Project	<b>IEEE 802.16 Broadband Wireless Access Working Group</b> < <a href="http://ieee802.org/16">http://ieee802.org/16</a> >		
Title	<b>Correction of inconsistencies in 802.16-2004 OFDMA mode repetitions and data mapping to burst</b>		
Date Submitted	<b>2004-08-25</b>		
Source(s)	Yigal Leiba Yossi Segal Zion Hadad Itzik Kitroser Runcom Ltd.	Voice:+972-3-9528440 <a href="mailto:yigall@runcom.co.il">yigall@runcom.co.il</a> <a href="mailto:yossis@runcom.co.il">yossis@runcom.co.il</a> <a href="mailto:zionh@runcom.co.il">zionh@runcom.co.il</a> <a href="mailto:Itzikk@runcom.co.il">Itzikk@runcom.co.il</a>	Fax:+972-3-9528805
	Tal Kaitz Alvarion Ltd.	Voice: +972-36457834 <a href="mailto:tal.kaitz@alvarion.com">tal.kaitz@alvarion.com</a>	Fax: +972-36456290
	Yuval Lomnitz Yigal Eliaspur Intel	Voice: +972-547-884877 <a href="mailto:yuvall@envara.com">yuvall@envara.com</a> <a href="mailto:yigal.eliaspur@intel.com">yigal.eliaspur@intel.com</a>

## Correction of inconsistencies in 802.16-2004 OFDMA mode repetitions and data mapping to burst

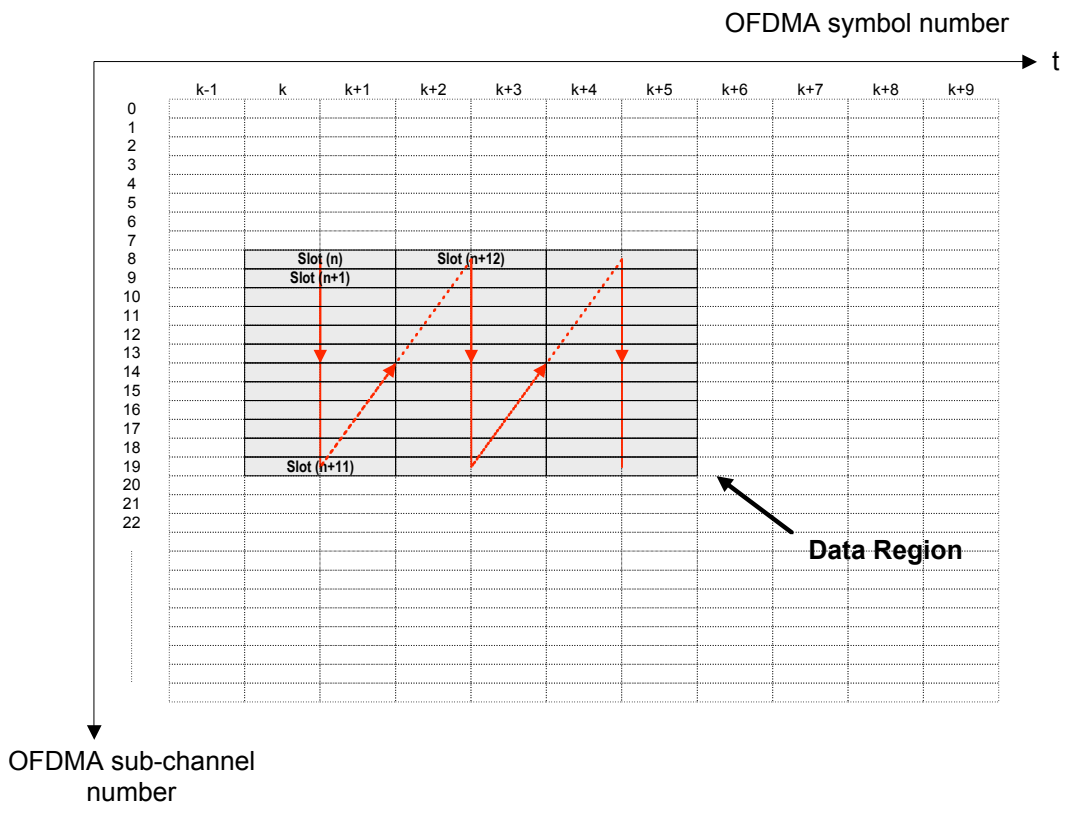
- 1) Segment the data into blocks sized to fit into one OFDMA slot.
- 2) Each slot shall span one or more subchannels in the subchannel axis and ~~two~~ one or more OFDMA symbols in the time axis (see Figure 216), as per the specific slot used. Map the slots such that the lowest numbered slot occupies the lowest numbered subchannel in the lowest numbered OFDMA symbol.
- 3) Continue the mapping such that the OFDMA ~~symbol~~ subchannel index is increased. When the edge of the Data Region is reached, continue the mapping from the lowest numbered OFDMA ~~symbol~~ subchannel in the next ~~subchannel~~ available symbol.

The UL mapping consists of two steps. In the first the OFDMA slots allocated to each burst are selected. In the second steps the allocated slots are mapped.

- 1) Segment the data into blocks sized to fit into one OFDMA slot.
- 2) Each slot shall span one or more subchannels in the subchannel axis and three OFDMA symbol in the time axis (see Figure 217). Map the slots such that the lowest numbered slot occupies the lowest numbered subchannel in the lowest numbered OFDMA symbol.
- 3) Continue the mapping such that the OFDMA symbol index is increased (skipping allocations made with UIUC=12,13, see 8.4.54). When the edge of the UL zone (which is marked with Zone\_switch\_IE) is reached, continue the mapping from the lowest numbered OFDMA symbol in the next available subchannel
- 4) An UL allocation is created by selecting an integer number of contiguous slots, according to the ordering of steps 1-3. This results in the general Burst structure shown by the gray area in figure 217.

- 1) Map the slots such that the lowest numbered slot occupies the lowest numbered subchannel in the lowest numbered OFDMA symbol.
- 2) Continue the mapping such that the Subchannel index is increased. When the last subchannel is reached, continue the mapping from the lowest numbered subchannel in the next OFDMA symbol that belongs to the UL allocation. The resulting order is shown by the arrows in figure 217.

*[Replace figure 216 on page 500 with the figure shown below]*

[Replace figure 217 on page 501 with the figure shown below]
